MEMORANDUM

SUBJECT: Item 3.5 DA2020/0514 – 1B Bolingbroke Parade, Fairlight

REFERENCE: McLaren Traffic Engineers Peer Review of Traffic Impact Assessment and request from the applicant to amend draft condition 15 – Construction Traffic Management Plan

TRAFFIC AND PARKING PEER REVIEW OF REDEVELOPMENT OF MANLY BOATSHED AT 1B BOLINGBROKE PARADE, FAIRLIGHT NSW

FIGURE 1: PARKING SURVEY GRAPH

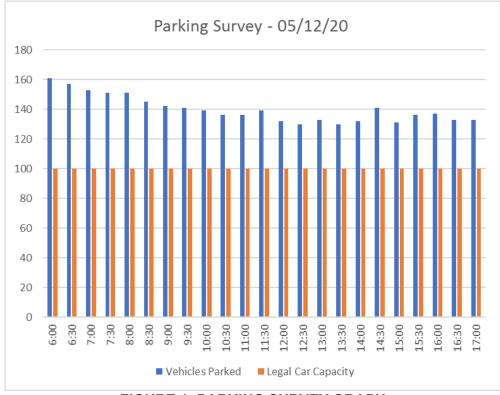
The parking count was completed by *Curtis Traffic Surveys* on Saturday 5th December 2020 from 6am to 5pm with data and images supplied in Annexure A and summary table in Figure 1. The proprietor Michael Curtis has decades of experience completing parking surveys and in the experience of this firm provides novel information beyond the numerical data. This is provided in the knowledge that parking survey context can significantly affect the numerical result. In this case he took several photos and completed a trundle wheel measurement of kerbside parking inventory. Further, the data was split into legally parked cars, legally parked motorcycles and illegally parked vehicles. The new survey found a parking capacity of 100 vehicles using a 5.4m end space and 6m middle spaces. This closely aligns with the capacity found by MTE using aerial imagery, though 12% lower than that found in the RRI. The parking count found a maximum of 161 vehicles at 6am and a minimum prior to 10am (the claimed peak dry storage usage) of 141 vehicles. Given there are 161 vehicles parked at 6am, the primary demand for parking is residents and that figure includes 7 motorcycles and 33 cars parked too close to an intersection, blocking a driveway or over the footpath. Throughout the survey period the minimum vehicle count was 130 and occurred a couple of times after midday. This absolute minimum figure included 6 motorcycles and 14 illegally parked vehicles. It can be seen then that the minimum parking demand was 130% of compliant parking supplied and that during the peak period of dry storage usage there was a minimum demand of 141% of compliant parking.

The local parking context of the site is therefore highly constrained due to demand exceeding supply regularly and residents are forced to park illegally on street during everyday operation. There is no additional capacity on street. The independent survey completed on behalf of MTE highlights the inaccuracies within the Traffix survey and no results or conclusions drawn within the RRI can be relied upon.

FIGURE 3: EXTRACT FROM PLANNING INGENUITY RESPONSE TO ISSUES M190009

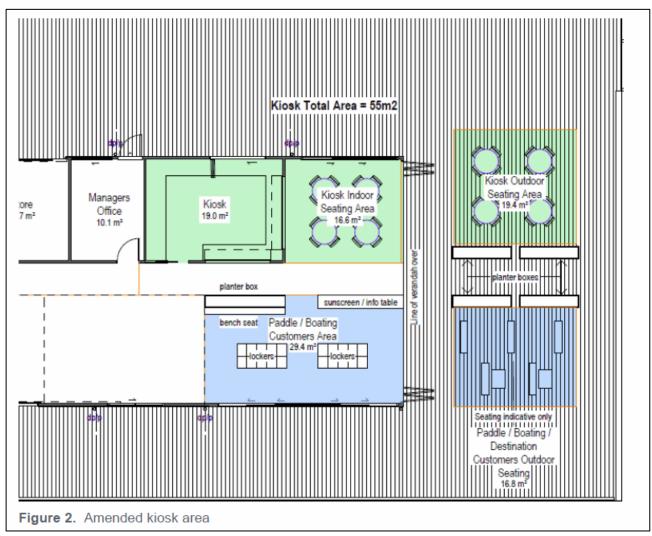
Considering the 7.5 visitors per day would all use the dedicated boating customer seats (5 bench seats with at least two per seat) shown in **Figure 3**, the parking generation of the kiosk to external users might be better related to just the 32 seats designated within the arbitrary 55sqm shown on the plans. Further, it is common practice to require developments to provide parking to suit the 85th percentile capacity on-site, or 85% of 32 seats, being 27 seats. Let's also assume that patrons to the kiosk will have the same characteristics of travel as those surveyed for the kayak and SUP being 32% car drivers. This equates to 8.7 cars (9) alone for the visitors to the kiosk. This is importantly very similar to the rate found by the RMS guide which was 15 spaces per 100 sqm or 1 per 3 seats which would equate to 8.3 or 10.7 vehicles respectively. Once a staff space is added to the 8.7 cars found by mode share and seating capacity, the total is 9.7 cars which is almost exactly half-way

between the two RMS methods. The validity of the previous MTE analysis has now been confirmed by the patron survey completed by the applicant and it is emphasised that the development does not provide any additional parking to meet the new demand for the kiosk nor is the kiosk afforded a parking permit. The parking demand of patrons and staff will overspill beyond the existing constrained parking and result in adversely impacting the community amenity contrary to the SREP DCP.

The above does not consider the ample opportunity under regular operation for additional seating to be added in the available deck area which would further decrease local parking and noise amenity.
